TECHNICAL BULLETIN
Bell Helicopter **TEXTRON**

No. 230-03-36

MODEL AFFECTED: 230

SUBJECT: TAIL ROTOR GUARD SUPPORT, IMPROVEMENT OF

Figure 1 Tail Rotor Guard Installation (Before Modification)

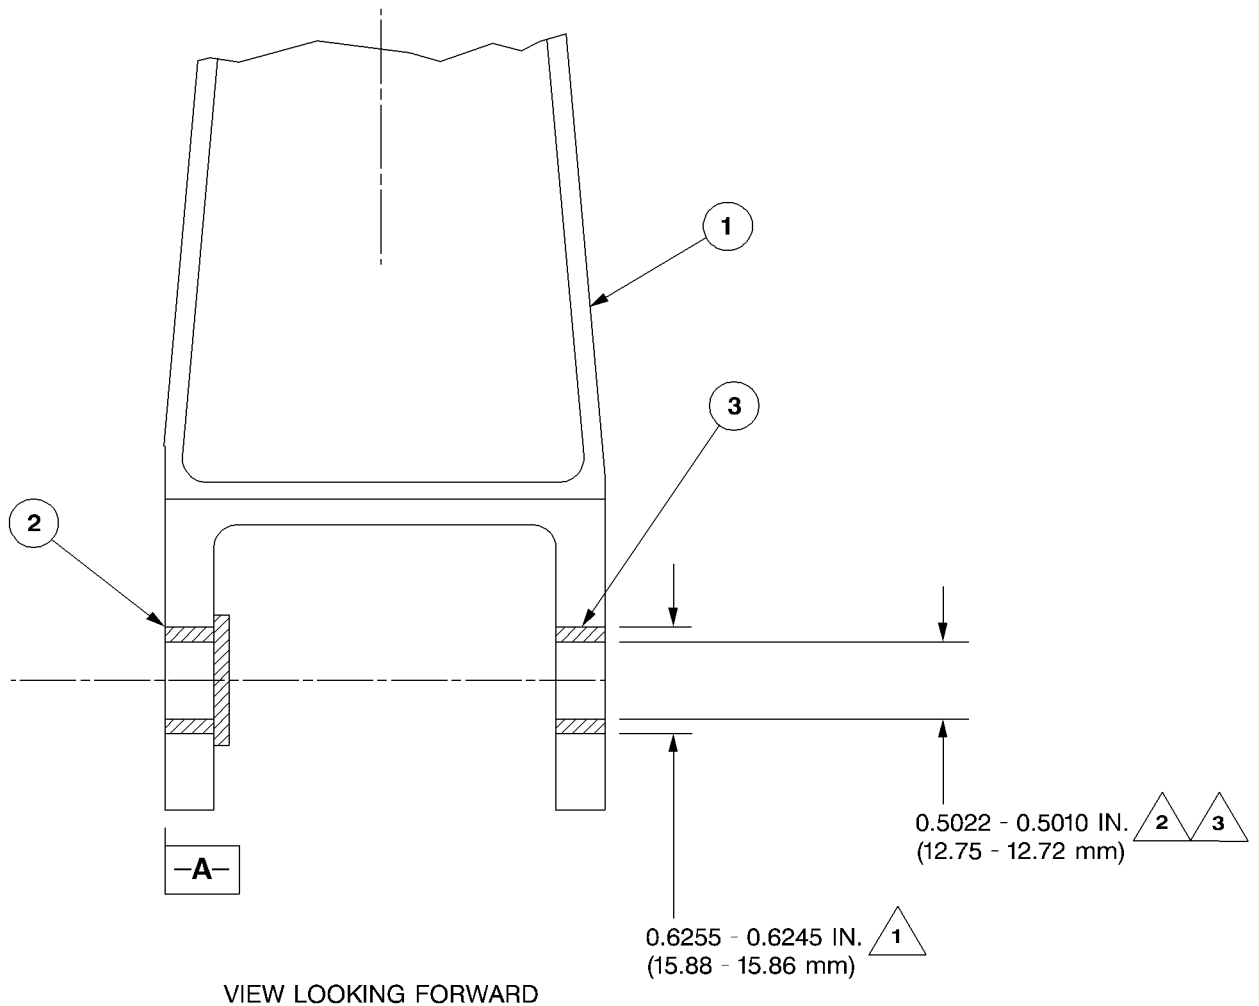
There are two supports that are made from aluminum castings that retain the tail rotor guard installation. The forward support 222-035-168-101 is attached to the tailboom and aft support 222-035-231-105 is part of the lower vertical fin. Reports indicate that hole elongation occurs in the forward and aft supports of the tail rotor guard. This bulletin introduces a bushing in the forward and aft supports to maintain the correct tolerance for mounting hardware.

1. Remove tail rotor guard assembly 222-035-350-105. Retain hardware for re-use. Replace any damaged hardware. Refer to BHT-230-MM-5 for instructions. Refer to Figure 1 for location.

Figure 2 Forward Support Modification - (sheet 1 of 2)

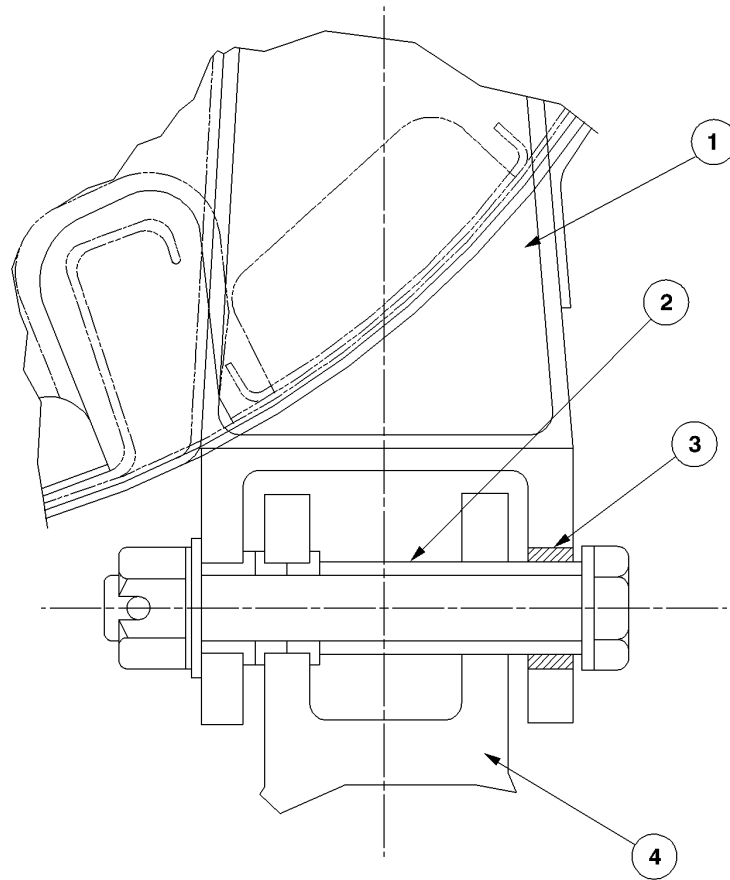
2. Inspect exposed area of fitting for corrosion and damage, visually inspect area for cracks using a 10X magnifying glass. If additional damage is found then contact Bell Helicopter Product Support.
3. Drill and ream hole in support 222-035-168-101. Reamed hole must be perpendicular to surface "A" to within 0.005 inch (0.13mm). Refer to figure 2, sheet 1 for dimensions. Do not modify existing bushing install.
4. Debur edges of hole and clean area.

5. Apply primer TT-P-1757 to new bushing and reamed hole. Thermal fit new bushing 21-010A15-8 into support while primer is still wet. Ensure bushing is flush with both sides of lug. Refer to BHT-ALL-SPM, section 8-10 for bushing installation instructions. Allow primer to cure.
6. Ream inside diameter of bushing in line with opposite bushing. Refer to figure 2, sheet 1 for dimensions.
7. Prime all bare metal areas using MIL-P-23377. Re-finish as required.

- $\triangle 1$ Hole in casting must be perpendicular to surface -A- to within 0.005 inch (0.13 mm).
- $\triangle 2$ Install bushing 21-010A15-8 with wet zinc chromate primer TT-P-1757.
- $\triangle 3$ Ream I.D. of bushing inline with opposite existing bushing.

Figure 2 Forward Support – After Modification - (sheet 2 of 2)

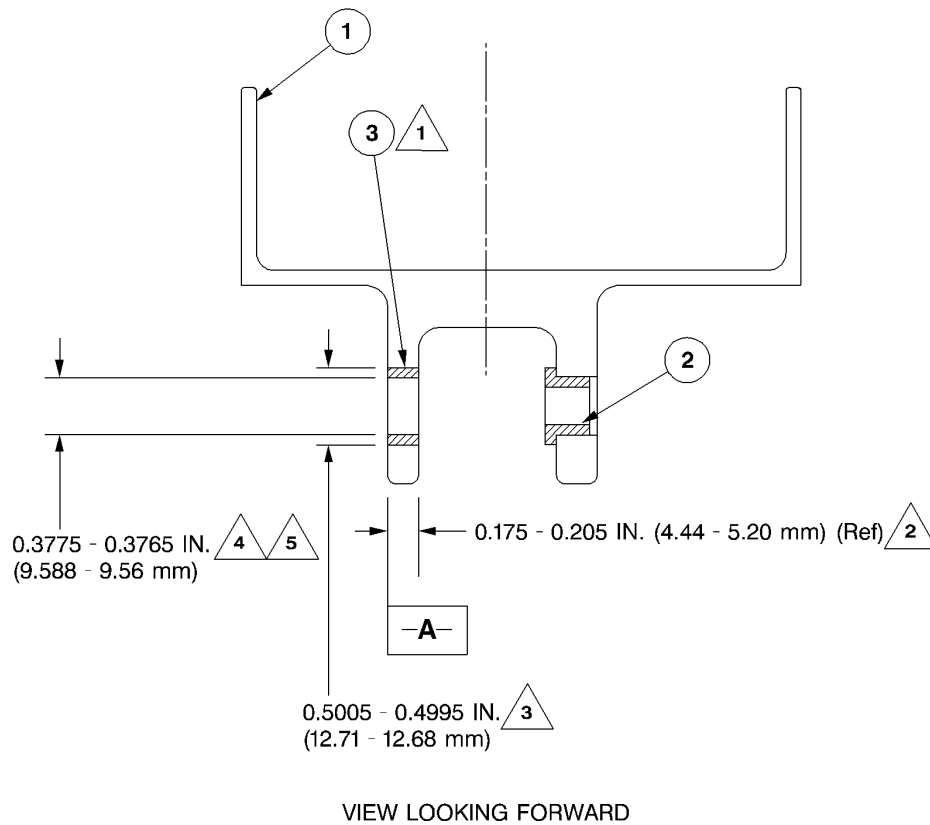
6. Apply primer TT-P-1757 to new bushing and reamed hole. Thermal fit new bushing 21-008A11-7 into support while primer is still wet. Ensure bushing is flush with both sides of lug. Refer to BHT-ALL-SPM, section 8-10 for bushing installation instructions. Allow primer to cure.
7. Ream inside diameter of bushing in line with opposite bushing. Refer to figure 3, sheet 1 for dimensions.
8. Re-assemble tail rotor guard installation as indicated in BHT-230-MM-5 and figure 2, sheet 2, figure 3 sheet 3 of this bulletin.

Figure 3 Aft Support Modification - (sheet 1 of 3)

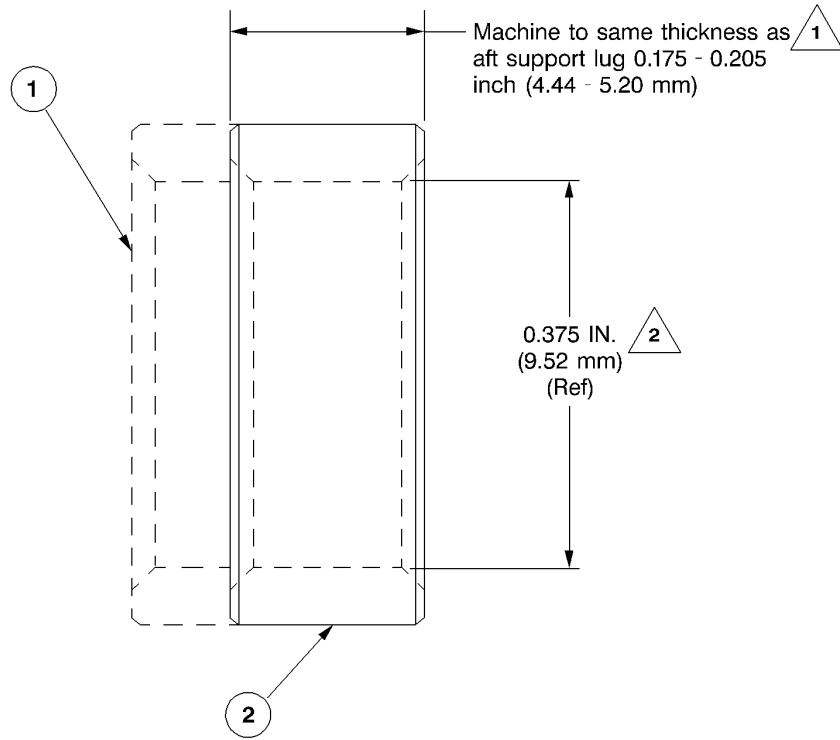
1. Remove tail rotor guard assembly 222-035-350-105, if installed. Retain hardware for re-use. Replace any damaged hardware. Refer to figure 1 for location.
2. Inspect exposed area of fitting for corrosion and damage, visually inspect area for cracks using a 10X magnifying glass. If additional damage is found then contact Bell Helicopter Product Support.
3. Drill and ream hole in support 222-035-231-105. Reamed hole must be perpendicular to surface "A" to within 0.005 inch (0.13mm). Refer to figure 3, sheet 1 for dimensions. Do not modify existing bushing installation.
4. Debur edges of hole and clean area.

- 1 Machine new bushing 21-008A11-7 to existing lug thickness.
- 2 The lug on the aft casting may vary in thickness from 0.175 inch (4.44 mm) - 0.205 inch (5.20 mm).
- 3 Hole in casting must be perpendicular to surface -A- to within 0.005 inch (0.13 mm).
- 4 Install bushing 21-008A11-7FM with wet zinc chromate primer TT-P-1757.
- 5 Ream I.D. of bushing 21-008A11-7FM inline with opposite existing bushing.

Figure 3 Aft Support Bushing (sheet 2 of 3)

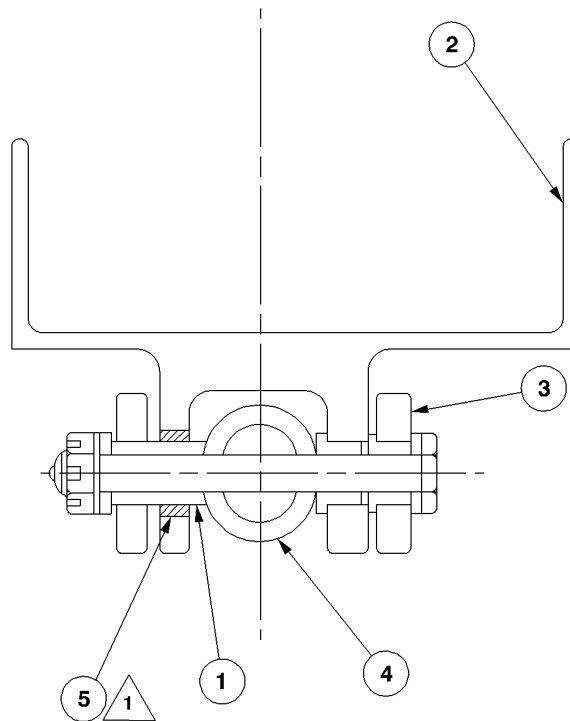
5. Locally machine new bushing 21-008A11-7 to length and chamfered as shown in figure 3, sheet 2.

- 1 Chamfer outer diameters to 0.005 inch (0.13 mm) - 0.015 inch (0.38 mm) x 40° - 50°, typical.
- 2 Chamfer inner diameters to 0.025 inch (0.63 mm) - 0.035 inch (0.88 mm) x 40° - 50°, typical.
